Intersection ID: 13086	Main Street: CENTRAL_AV	Cross Street: CLEMENT_AV	Location:	NE
ADA ID: 68446A4D93CC	Ramp Type: Perp	Initial Pass/Fail: Fail	Overall Compliance: No	Severity Score: 13.75

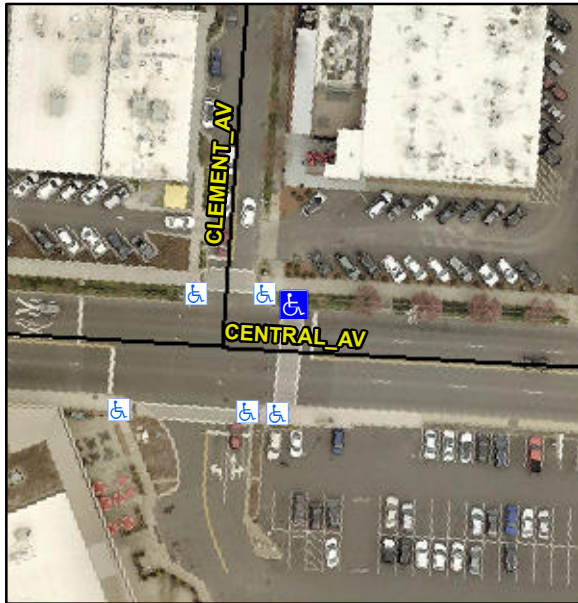
R304.2.2, R304.5.3

Compliance	Description	Data	Compliance	Description	Data
N/A	Ramp Length (in)	95.0	No	Ramp Slope (%)	9.4
Yes	Ramp Width (in)	69.0	No	Ramp XSlope (%)	2.4
N/A	Flare Type LT	N/A	N/A	Flare Type RT	N/A
N/A	Flare Slope LT (%)	N/A	N/A	Flare Slope RT (%)	N/A
N/A	Flare Traversable LT?	N/A	N/A	Flare Traversable RT?	N/A
N/A	Landing Length (in)	N/A	N/A	DWS Provided?	N/A
N/A	Landing Width (in)	N/A	N/A	DWS Contrast?	N/A
N/A	Landing Slope (%)	N/A	N/A	DWS Length (in)	N/A
N/A	Landing X Slope (%)	N/A	N/A	DWS Full Width?	N/A
N/A	Landing Curb? (Y/N)	N/A	N/A	DWS Offset (in)	N/A
N/A	Shared Landing?	N/A			
N/A	Gutter Ponding?	N/A	N/A	Gutter Slope (%)	N/A
N/A	Gutter Lip Ht (in)	N/A	N/A	Gutter X Slope (%)	N/A
N/A	Painted X Walk1?	Yes	N/A	Painted X Walk2?	N/A
	X Walk 1 Direction	To S		X Walk 2 Direction	N/A
N/A	X Walk 1 Width (in)	122.0	N/A	X Walk 2 Width (in)	N/A
	X Walk 1 Slope (%)	4.5		X Walk 2 Slope (%)	N/A
	X Walk 1 X Slope (%)	1.7		X Walk 2 X Slope (%)	N/A

Remove & Replace Entire Ramp.
